BMW MOTORRAD GMBH Techn.Kundendienst R-VK-11 ma/ur	Motorcycles R80/7-R100RS Technic Group: Engine	Munich, June 78 11 007 78 (1047R)
--	--	--

Subject: Piston and Wrist Pin Changes

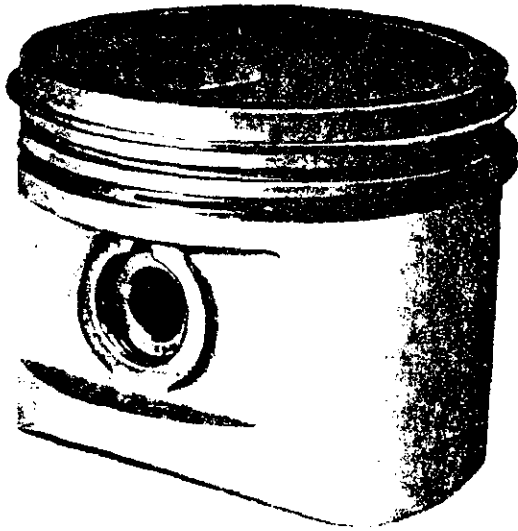
and all R 80/7 since the introduction of this model. The piston design was improved, the circlips are now secured to the wrist pin (external) instead of the inside of the piston (see attached pictures). The dome shape was changed in order to avoid excessive carbon build-up with a better flow pattern.

The compression ratio is the same, or 9:1.

Due to the slight increase in weight, pistons with internal or external circlip location can not be installed singly but must match in both cylinders. Also when ordering watch for the (+) and (-) markings on the piston removed. Never mismatch the pistons; consider them as identical pairs.
